# CITY PLANNING COMMISSION

- APPLICATION:**
- A. Negative Declaration
  - B. Special Permit to construct an office/warehouse building in the Light Industrial/Planned Unit Development (M-1S PUD) zone.

**LOCATION:** 175 Opportunity Street

**PROPOSAL:** The applicant is requesting the necessary entitlements to construct a 23,870 sq. ft. warehouse with 2,890 sq. ft. office use.

# SITE PLAN

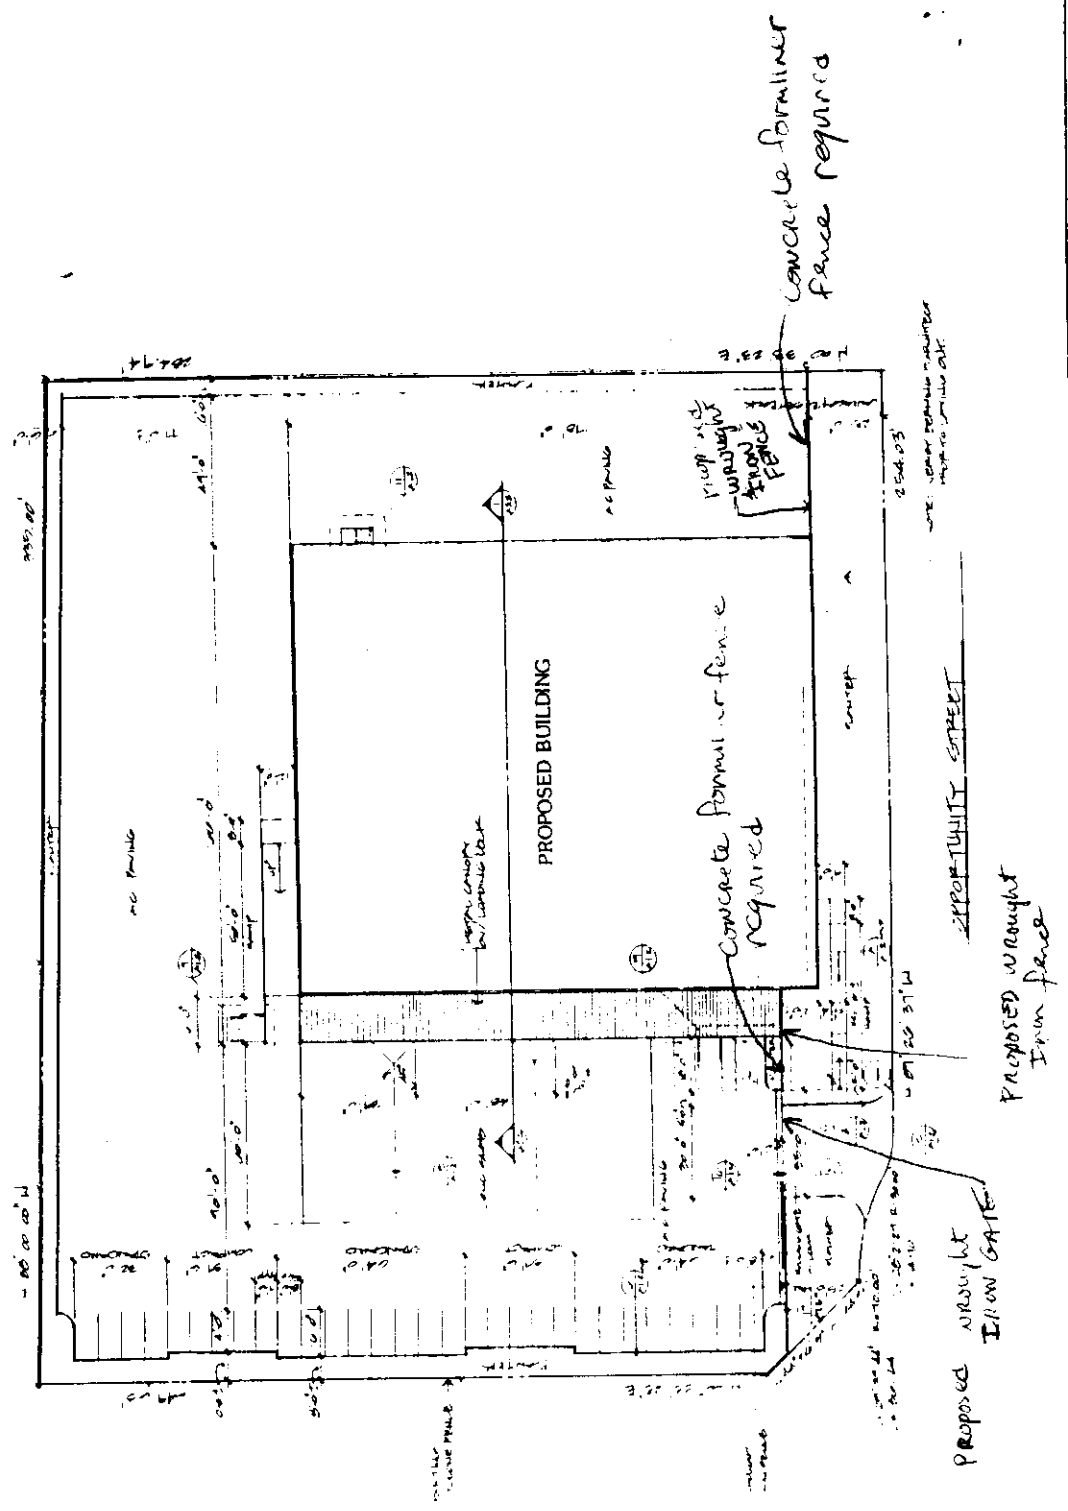
- the formliner shall be extended around the entire building (see elevations).
- a concrete fence with a formliner shall be constructed instead of the proposed wrought iron fence along the south property line. This concrete fence shall match the proposed building formliner. The concrete fence with formline shall be the same height as the proposed wrought iron fence (see site plan).

- a. Gate shall have "knox-box" locks. Contact Fire Department: 449-5480.
- b. On grading or site plan include:
  1. Existing fire hydrants (F.H.) and added ones.
  2. Show underground fire line with F.D.C. and valves.
  3. City water main and sizes.
- c. A fire hydrant is required within 50 feet of F.D.C. (double pumper - eight inch lateral).

4. A minimum 25 foot building setback from both the street and freeway is required.
5. Show location of trash containers on site plan. These shall be located in an inconspicuous manner.

12. Gate shall have "knox-box" locks. Contact Fire Department: 449-5480
13. On grading or site plan include:
  - a. Existing fire hydrants (F.H.) and added ones.

- b. Show underground fire line with F.D.C. and valves.
  - c. City water main and sizes.
14. A fire hydrant is required within 50 feet of F. D. C. (double pumper-eight inch lateral).

# ELEVATIONS

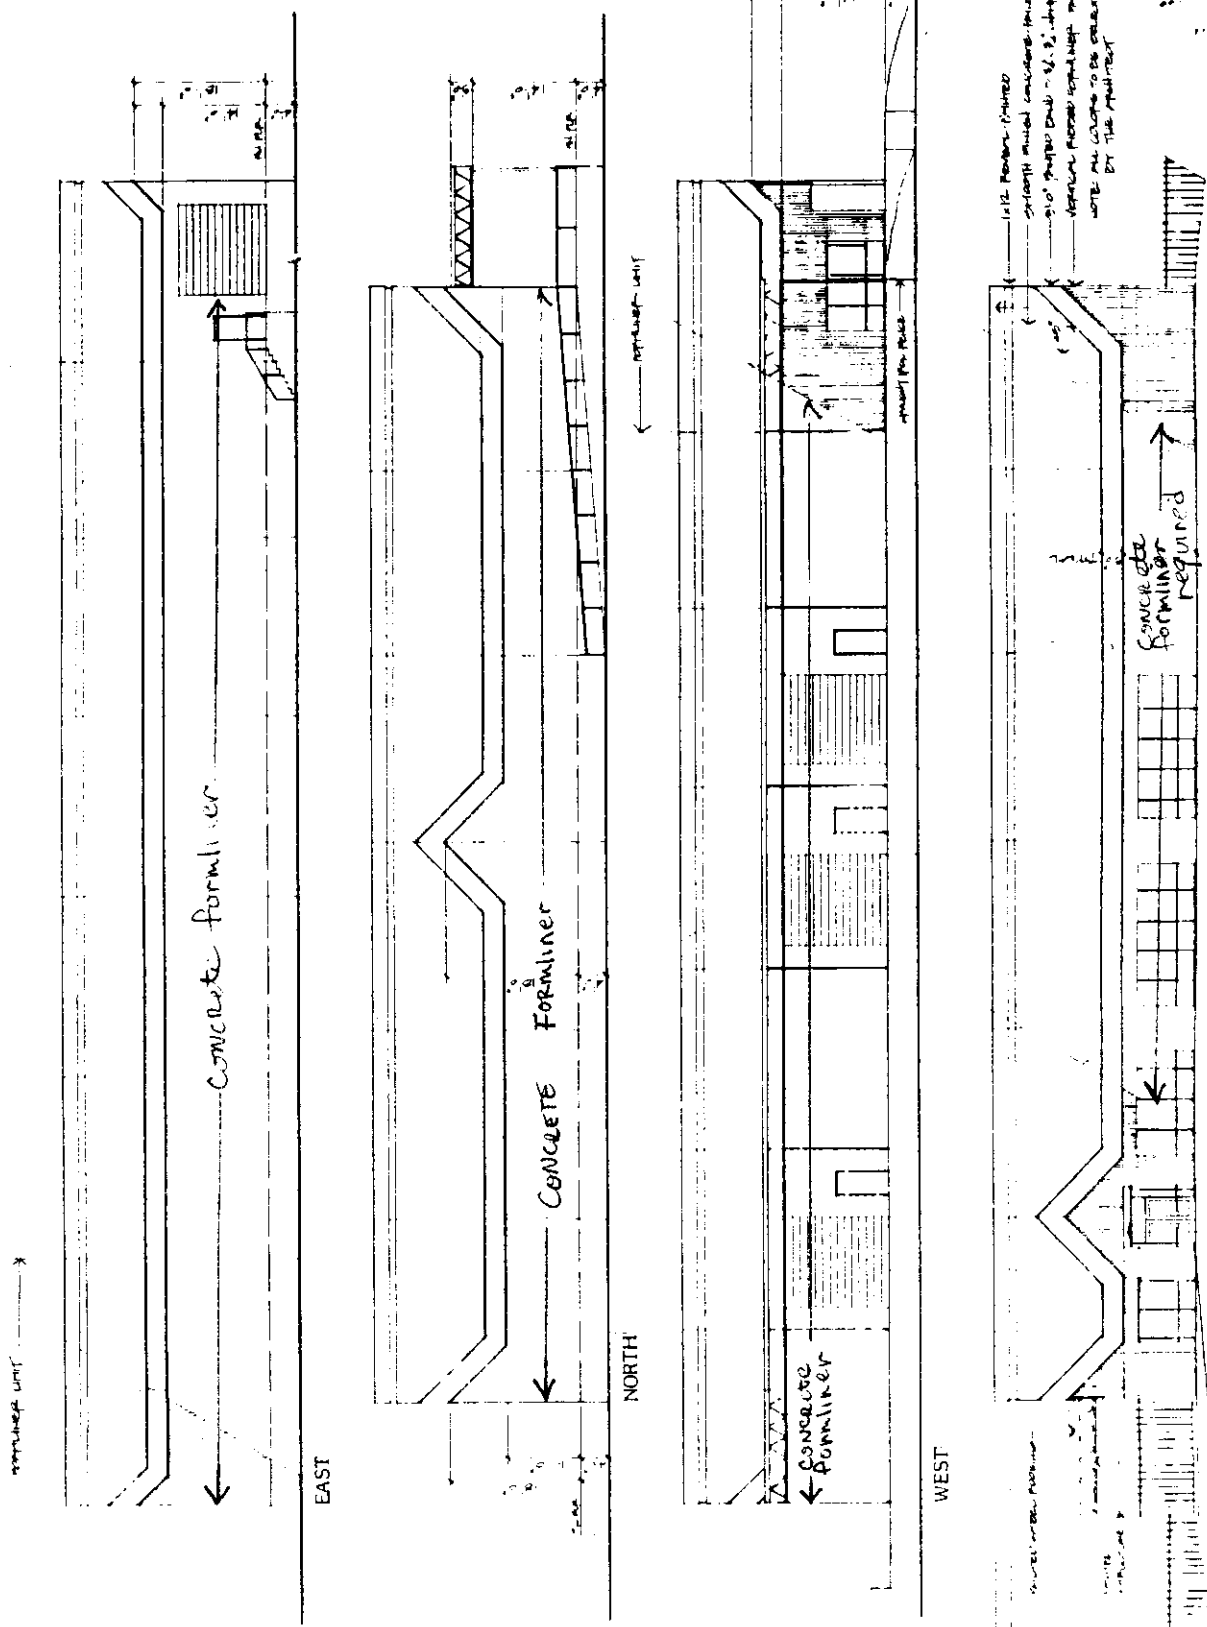
concrete formliner required

6. Revised elevations shall be submitted to Planning Staff for review and approval prior to the issuance of a building permit. These revised elevations shall include:

- a. The formliner shall be extended around the entire building.
  - b. A concrete fence with a formliner shall be constructed instead of the proposed wrought iron fence along the south property line. This concrete fence shall match the proposed building formliner. This concrete fence with formliner shall be the same height as the proposed wrought iron fence.
